UNITED STATES  
NUCLEAR REGULATORY COMMISSION  
WASHINGTON, D. C. 20555

ERRATA SHEET

NUREG/CR-1045

ACUTE EFFECTS OF INHALATION EXPOSURE TO URANIUM  
HEXAFLUORIDE AND PATTERNS OF DEPOSITION

Figure 8.  $UO_2F_2$  Inhalation: Distribution and Excretion

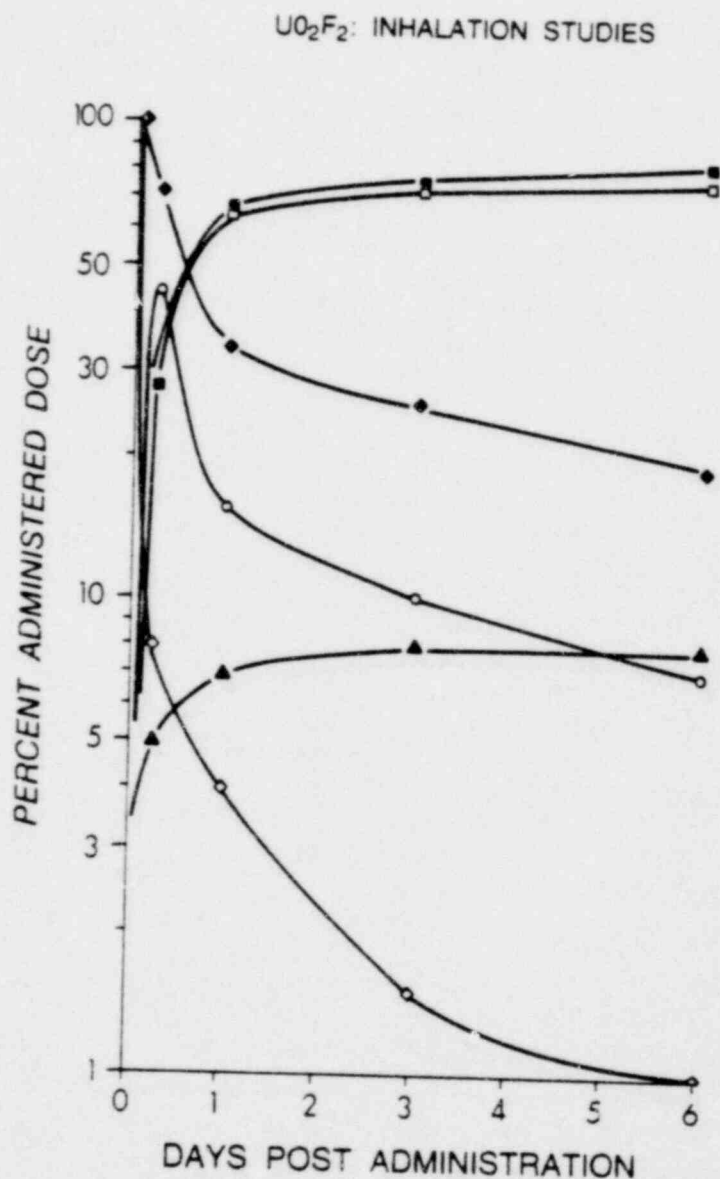
Please replace pages 29 and 31 with the attached corrected versions. The symbols in the legends were omitted from the original document.

This figure depicts graphically the data on absorbed uranium summarized in Table 3. The symbols have the following meaning: ■ cumulative U excretion; ○ cumulative urinary U elimination; ○ U content of kidneys; ▲ skeletal uranium content, ○ lung U content, and ◆ whole body U burden.
